**Addendum No. 2  
January 19, 2024**

Project: **Lennox High School Addition**  
Lennox, South Dakota  
Architecture Incorporated Project No.: 2982

Architect: Architecture Incorporated

**A** BUILDING SECTION - AREA G  
SCALE: 1/8" = 1'-0"

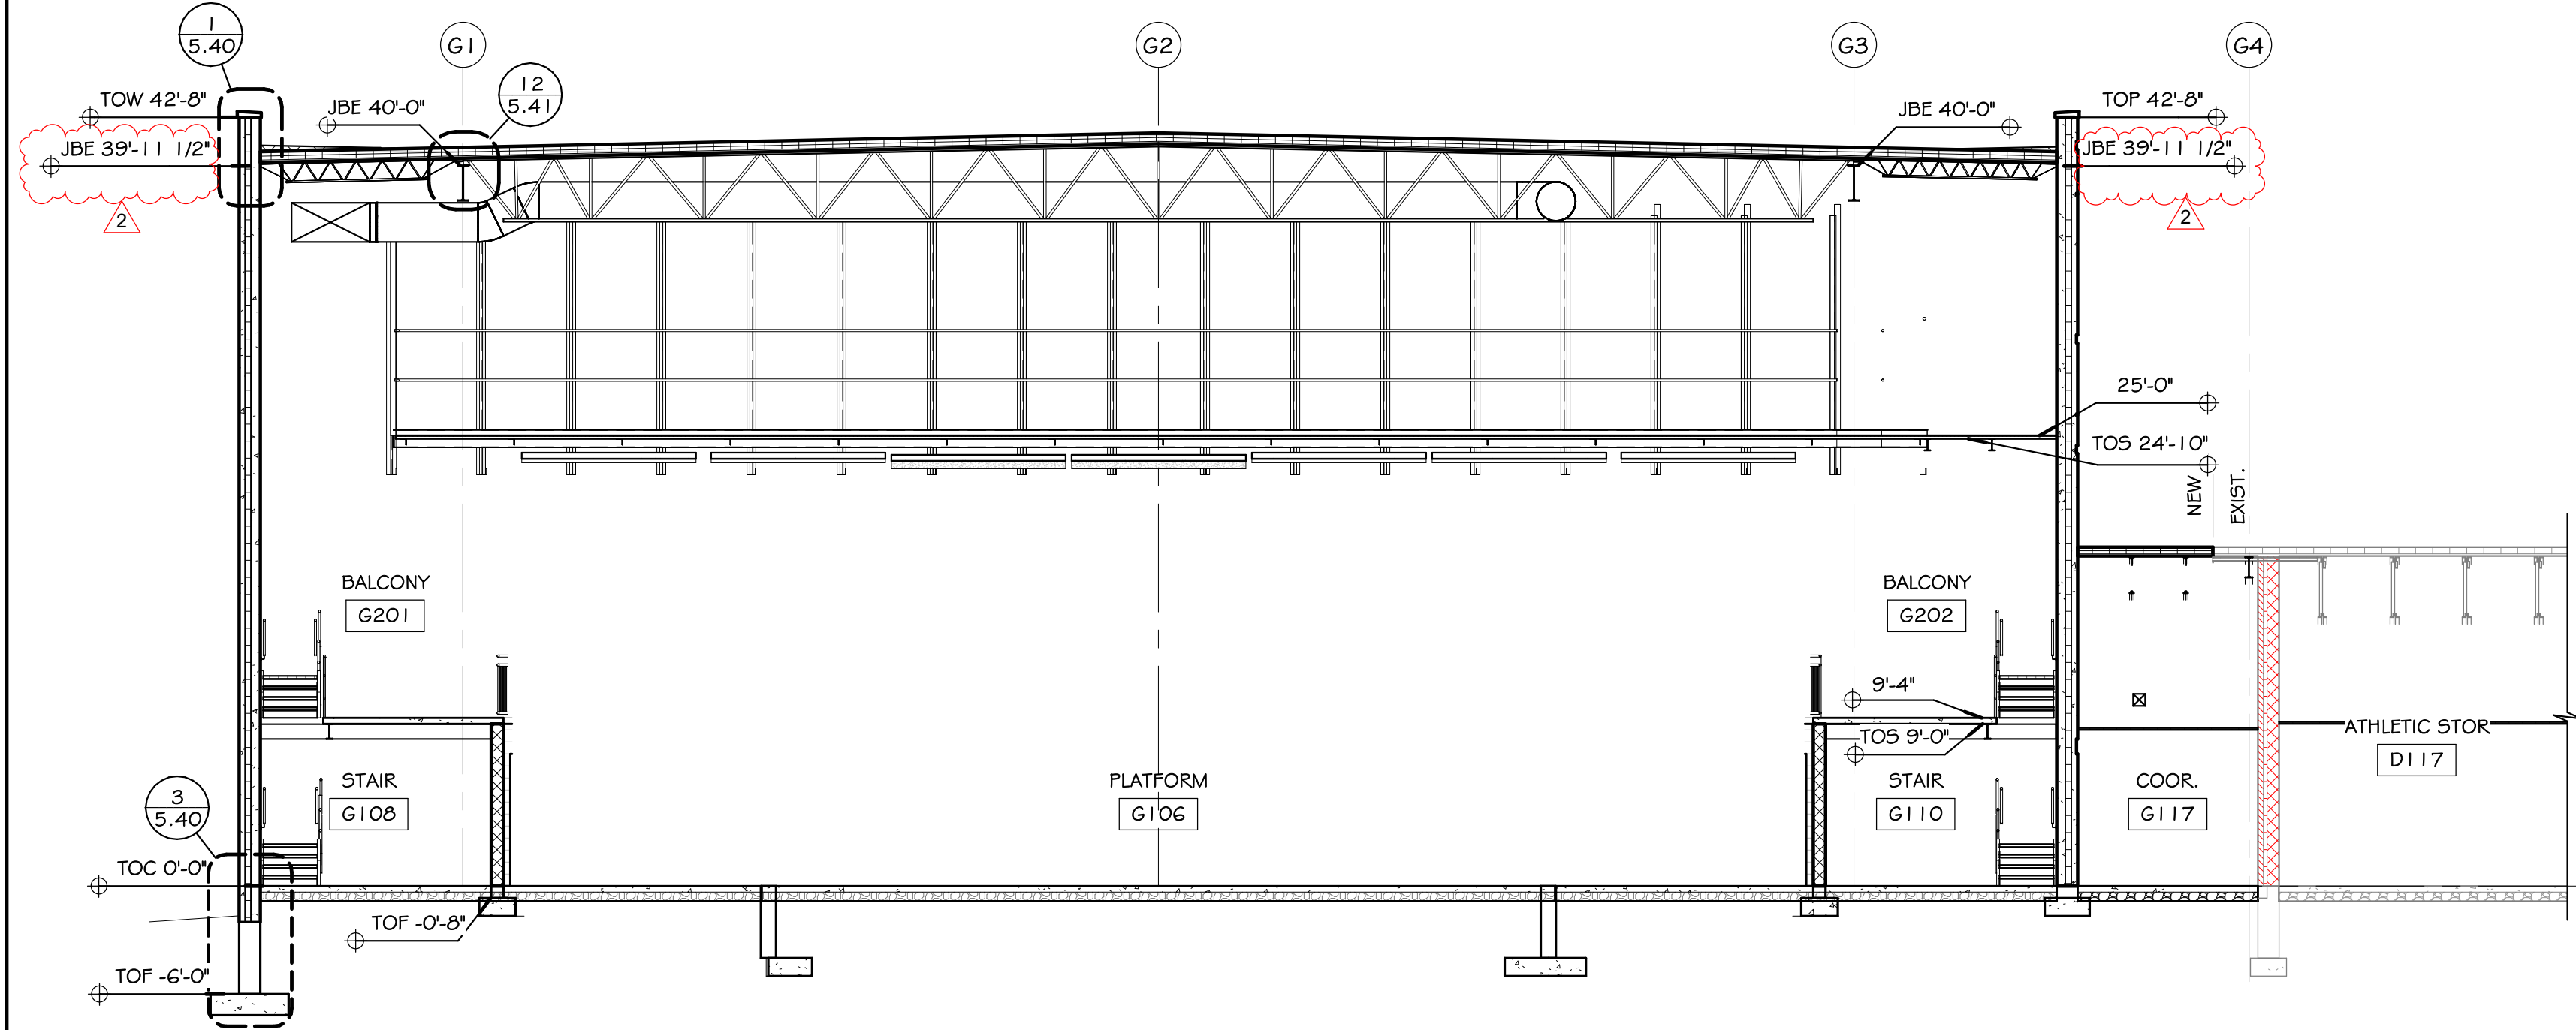
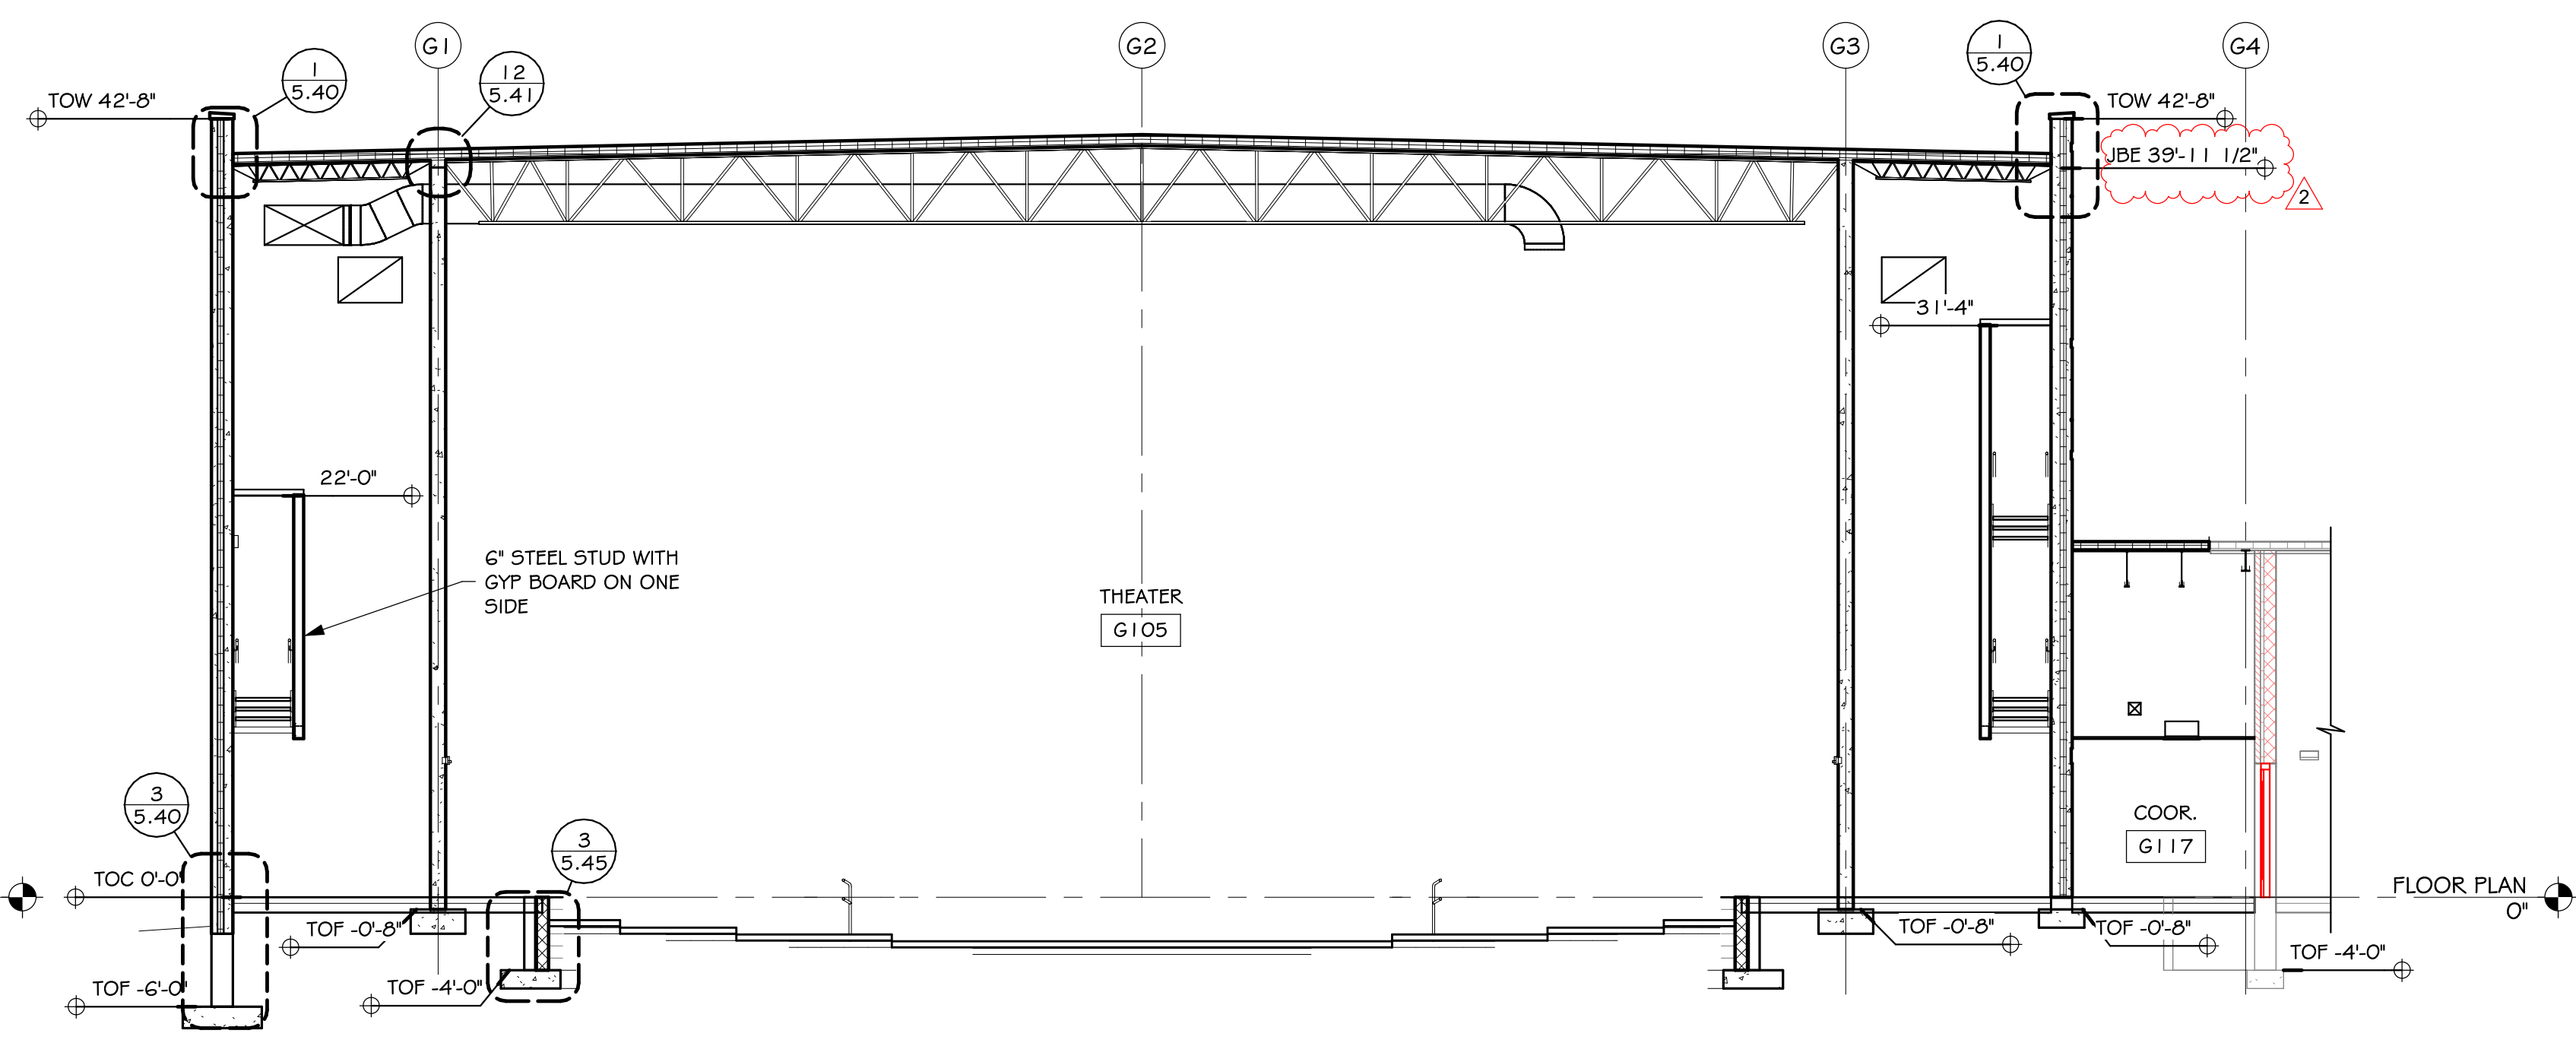
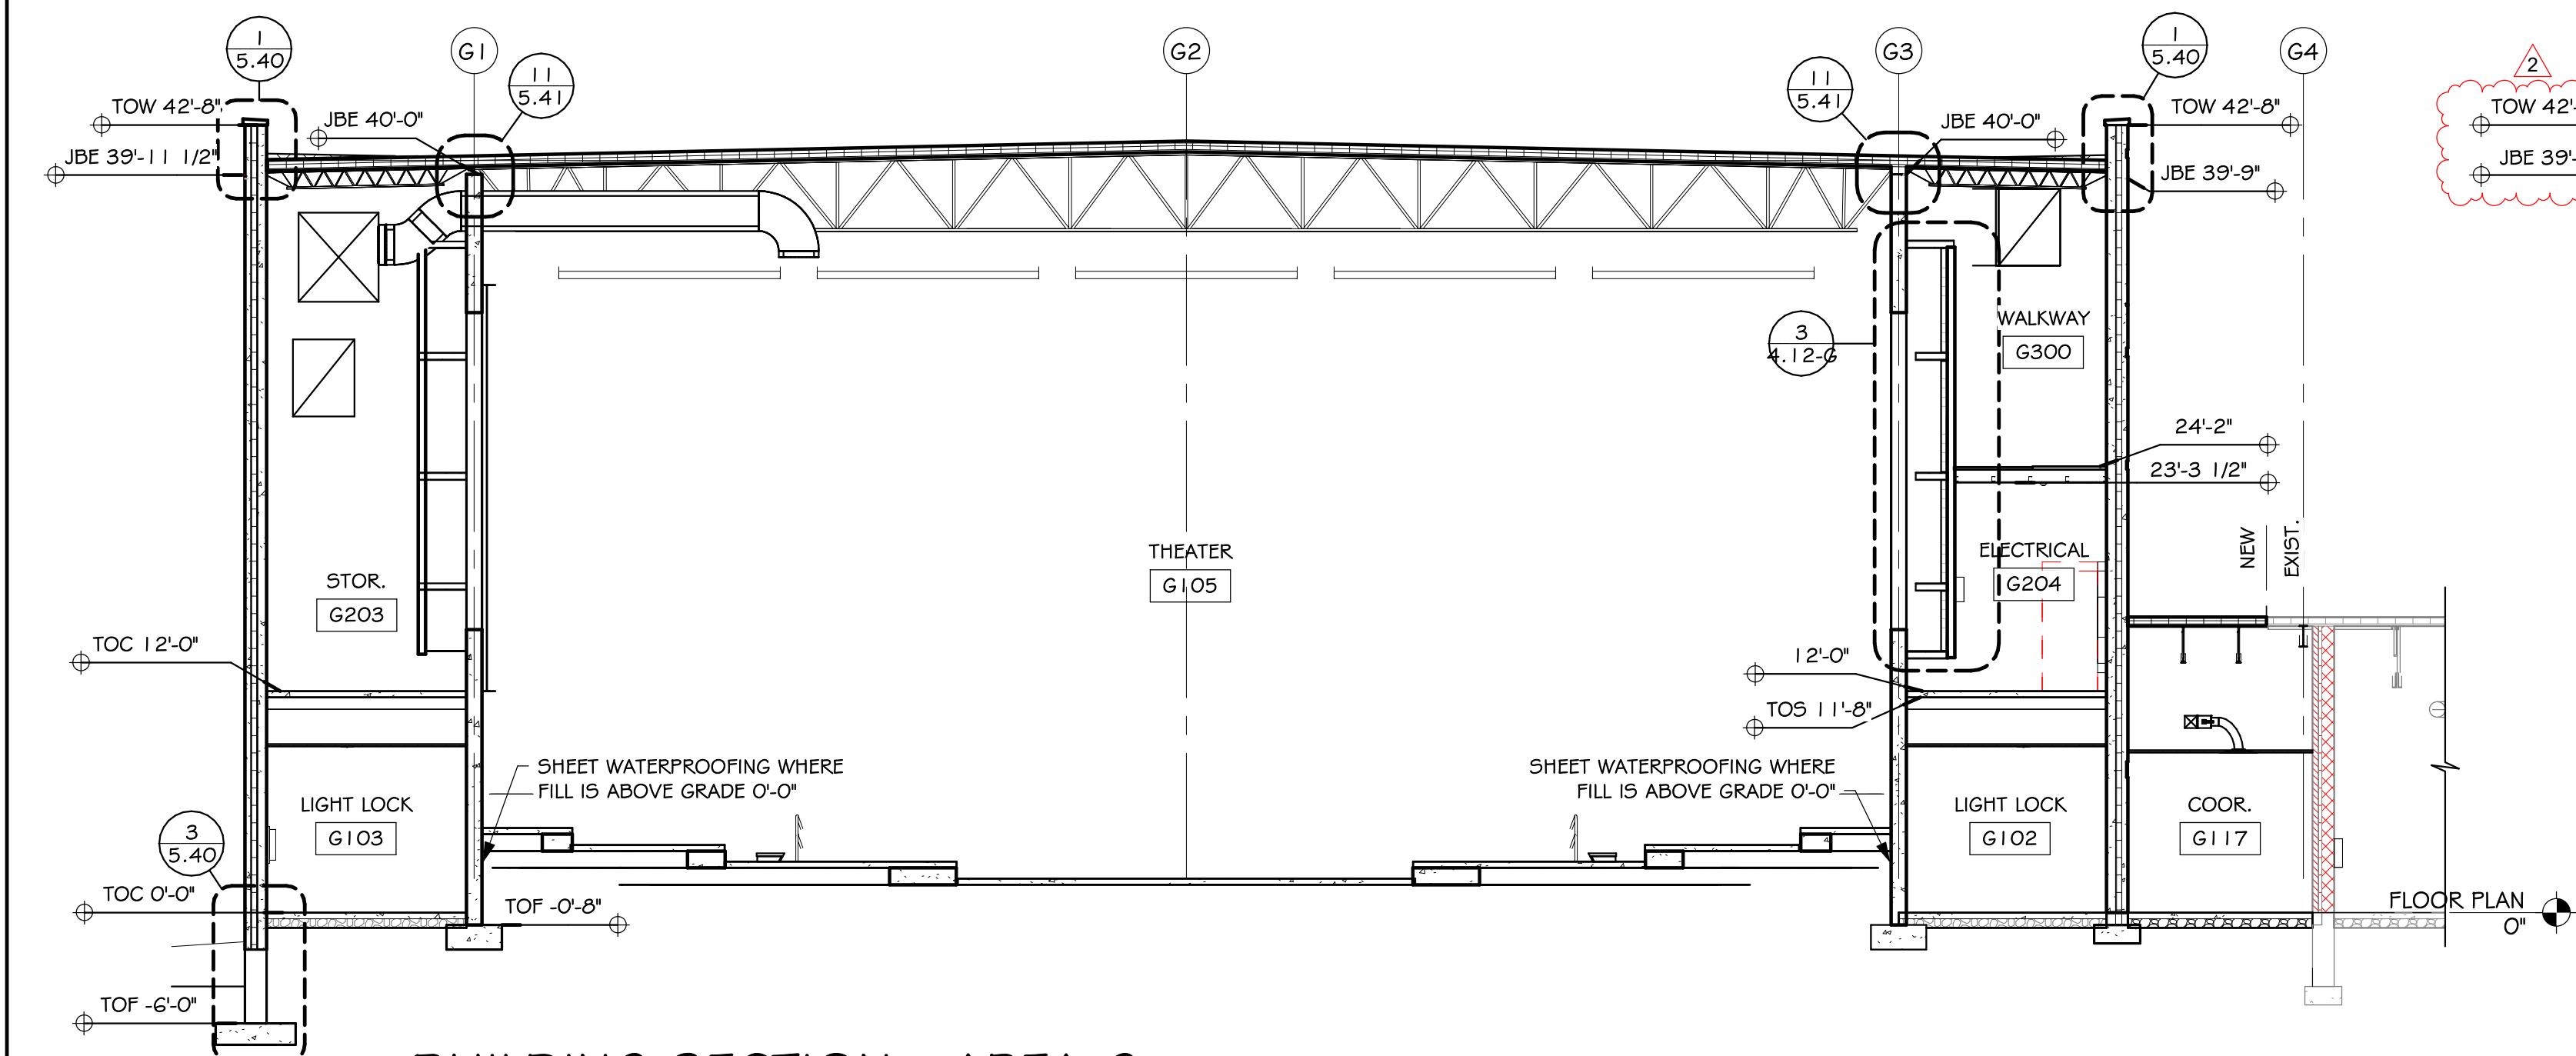
31) SHEET 5.21 – BUILDING SECTIONS

- a) Reference *revised* drawing Sheet 5.21, dated 1-18-24, attached to the end of this addendum for the following:
  - i. Additional wall detail callouts have been added to building sections A, E & F.
  - ii. Top of wall elevations have been added to building section E.
  - iii. Joist bearing elevations have been added to building sections B, C, E & F
